**FINDING OF NO SIGNIFICANT IMPACT AND
FINAL SUPPLEMENTAL ENVIRONMENTAL ASSESSMENT
APRIL 1998**

BLUE DIAMOND DETENTION BASIN

SUPPLEMENTAL ENVIRONMENTAL ASSESSMENT

**Table I-2
Chain of Command for Clark County Flood Control District
Response Plan Implementation at Blue Diamond Detention Basin**

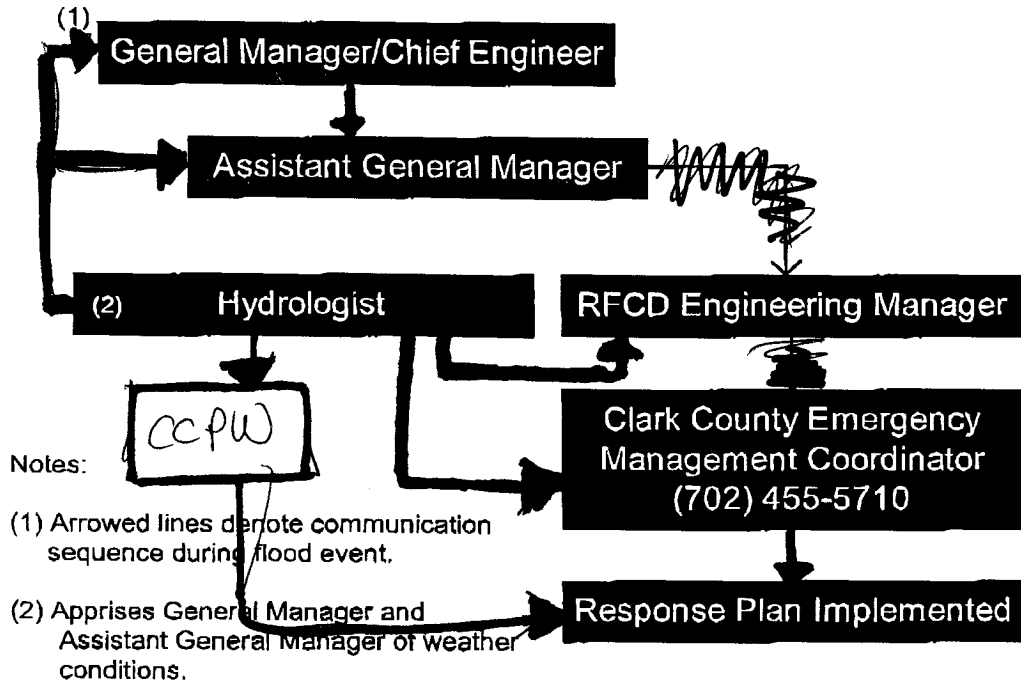
9. Table I-2. Provide Chain of Command for CCPW, Project Operator, in Table. Include District's role as owner of flood threat recognition (gages).

Response: *Table I-2 was modified to show the response implementation plan only and not chain of commands of both agencies. CCPW is indicated as Project Operator and CCRFCD as owner of flood threat recognition system (gages).*
